STATE OF VERMONT
AGENCY OF TRANSPORTATION

RECORD PLANS

PROPOSED IMPROVEMENT
BRIDGE PROJECT

ROUTE NO : VT RTE 30 (MINOR ARTERIAL) BRIDGE NO : 30

FRAMING PLAN

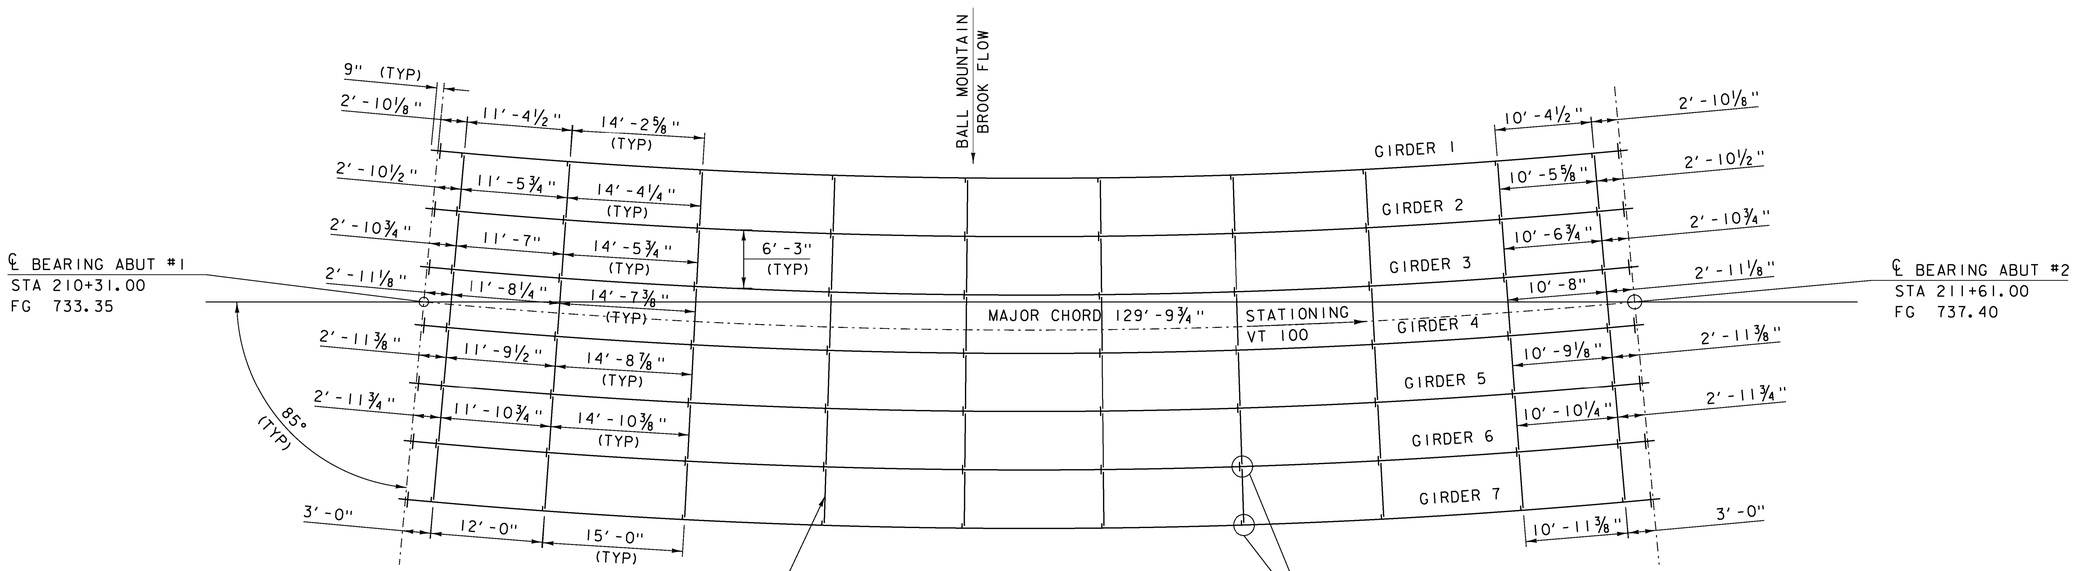
GIRDER DIMENSION TABLE				
GIRDER	RADIUS	A (LENGTH)	B TOP FLANGE PLATE THICKNESS	C BOTTOM FLANGE PLATE THICKNESS
#1	683.75'	PER SHOP DRAWING 128' - 5 3/4"	1"	1 1/4"
#2	690.00'	129' - ~~7 5/8"~~ 7 9/16"	1"	1 1/4"
#3	696.25'	130' - ~~9 5/8"~~ 9 7/16"	1"	1 1/4"
#4	702.5'	131' - ~~11 1/2"~~ 11 5/16"	1"	1 1/4"
#5	708.75'	133' - ~~1 1/2"~~ 1 1/16"	1 1/4"	2"
#6	715.00'	134' - ~~3 1/2"~~ 3"	1 1/4"	2"
#7	721.25'	135' - ~~5 3/8"~~ 4 7/8"	1 1/4"	2 1/4"

ABUTMENT 2 PLAN

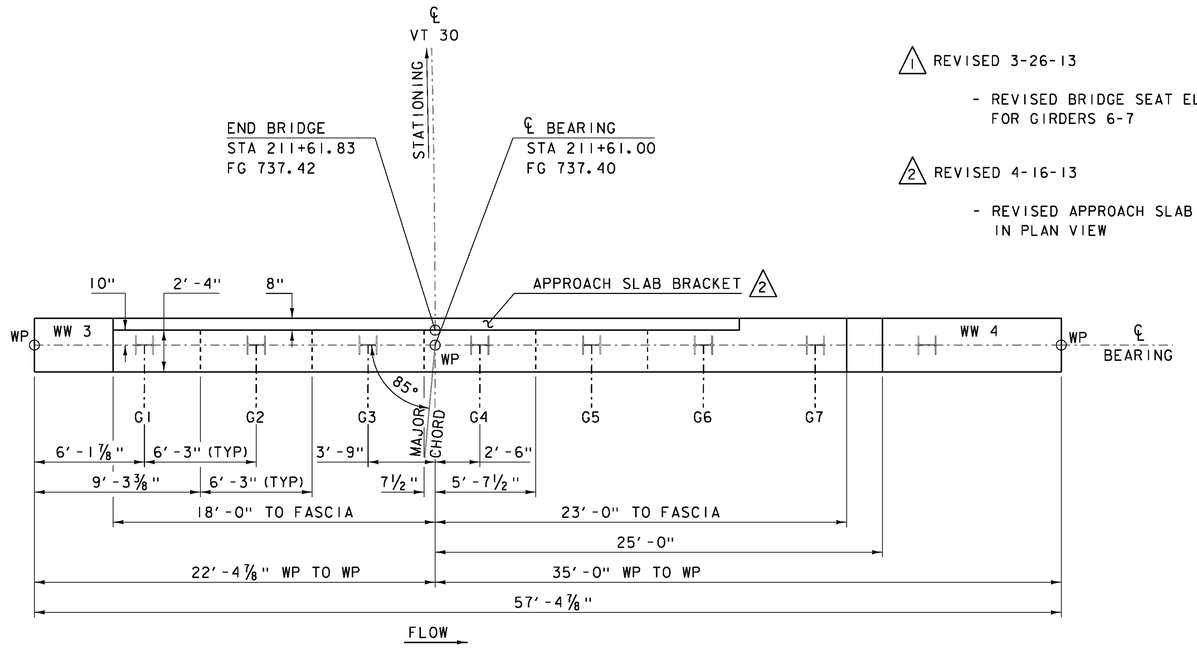
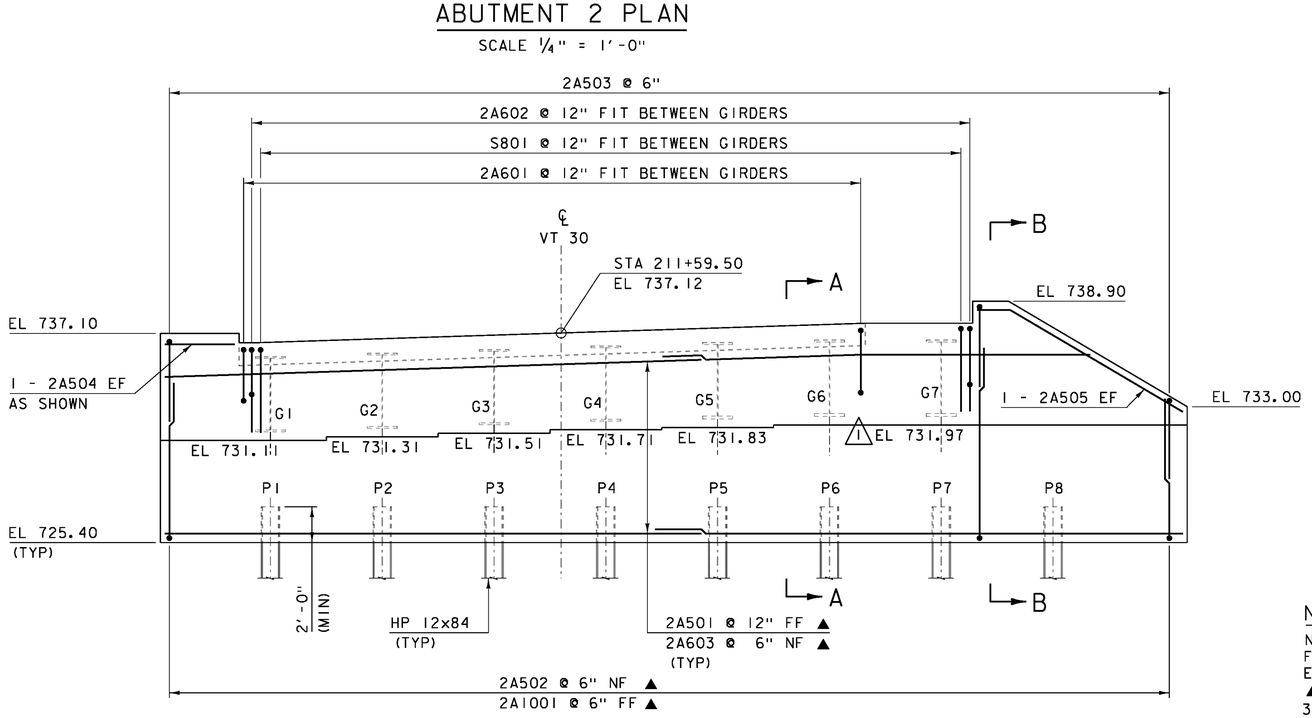
- REVISED APPROACH SLAB BRACKET WIDTH IN PLAN VIEW
